Docket Item # 6
BAR CASE # 2008-0113

BAR Meeting
July 23, 2008

ISSUE: Alterations
APPLICANT: Michael Johns
LOCATION: 910 North Columbus Street
ZONE: RB/Residential

Figure 3: Proposed alteration for front elevation.

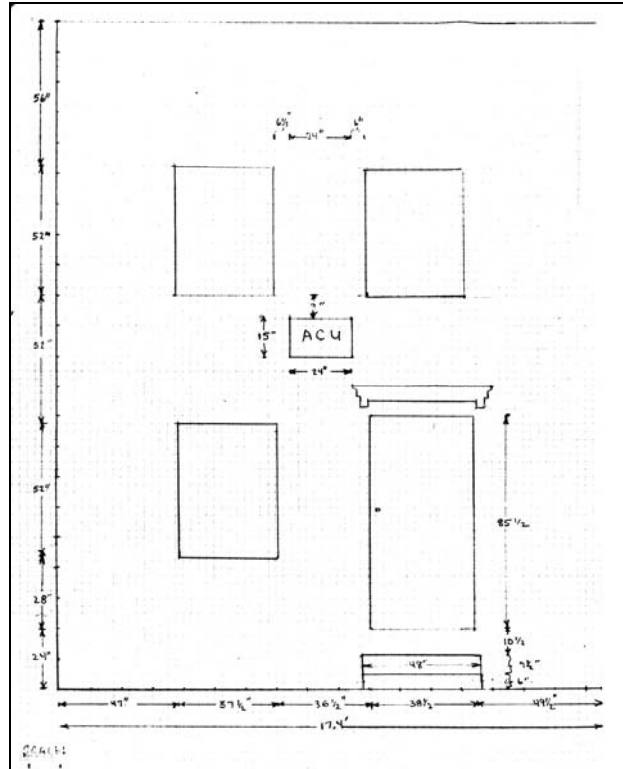
Although through-the-wall air conditioning units have been installed on neighboring properties, Staff was unable to locate BAR approval for such alterations. Staff has concerns regarding the removal of historic fabric for the units. In addition, the installation of such units will permanently alter the historic character of this post-World War II series of rowhouses. Staff finds that alternative solutions, such as installing an alarm system or security locks or hardware, or installing a skylight on the flat roof, would address the applicant's concerns. Staff does not support the installation of through-the-wall air conditioning units.

Staff recommends denial of the Certificate of Appropriateness.

Figure 4: Proposed alteration for rear elevation.

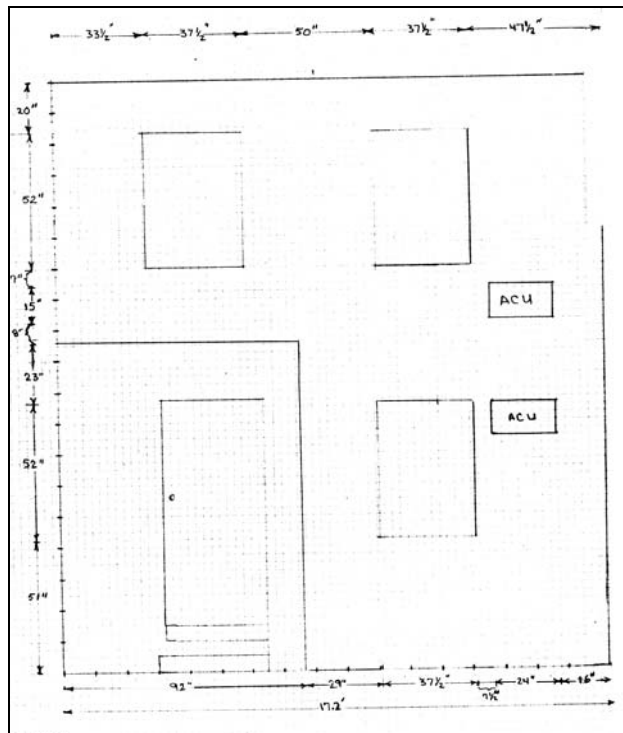
The rear of the dwelling is currently minimally visible from the rear alley. There is a carport/garage structure and fence at the rear of the property obstructing views of this elevation.
